| From: | Chou, Rich |
|--------------|--|
| Subject: | FW: Monday NCRs |
| Attachments: | 0015_insideAverage Moblity.jpg; Nov 21 markup - Containment Unfolded Graphics_IR Mosaic.pdf |

NCR 368389 identified a crack in the containment wall inside the Intermediate Building in the area below the equipment hatch based on the Impulse Response (IR) Testing and confirmed by Core Boring. The Core Boring was in the vicinity of the <u>highest average IR mobility value</u> and the crack width or gap was measured at 0.009" to 0.016" which is equivalent to 1/64". Please provide the picture or drawing to show the exact location and more detail information.

Containment "Unfolded" – Buttress 2 to 5 Updated Nov 20th (Mosaic IR Overlay scale is approximate)

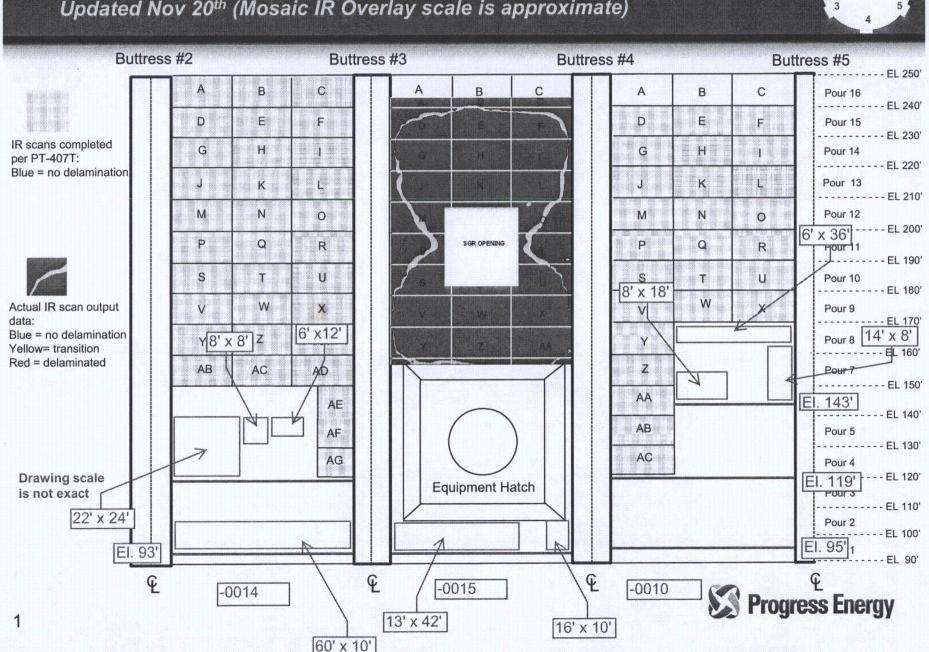
I forward the attachments for your information. The average mobility or ratio on the crack area in the first attachment is about 1.30. Per CTL testing engineer, the crack will start to be seen when the mobility or ratio is 0.7 or above. Therefore, the gap of 1/64" identified by the testing and core boring is not matched the crack criteria. Can you ask CTL to do the evaluation why the crack is so small? Is it possible another larger crack nearby and is not identified?

As I understood when I observed the IR testing and discussed with CTL Testing Engineer, he said that the higher value of the IR is the higher or wider gap. There was a maximum gap of 2 and 1/4" identified in the Containment wall. This small gap identified might not be the real size of the gap. It is potentially that there is a bigger gap nearby and is not identified yet.

The first file is the scan data for the area below the equipment hatch. The red indicates where the crack was found. The second file is the layout of 180 degrees of the building. The scan data in the first file is the 13' x 42' rectangle below the equipment hatch

- 1. The area in question is a few feet below the reinforced concrete section near the lower west corner of the equipment hatch. This is on the left side when looking from outside the containment.
- 2. There is just one small area (square inches) showing the highest IR readings. The core bore was done there and confirmed a crack.
- 3. The crack is about 8 inches deep from the surface, but is not in plane with the hoop tendons.
- 4. There is a larger area of about $4' \times 4'$ that shows possible chance of a crack.
- 5. The whole area that was scanned was $13' \times 42'$ with other areas appearing solid.
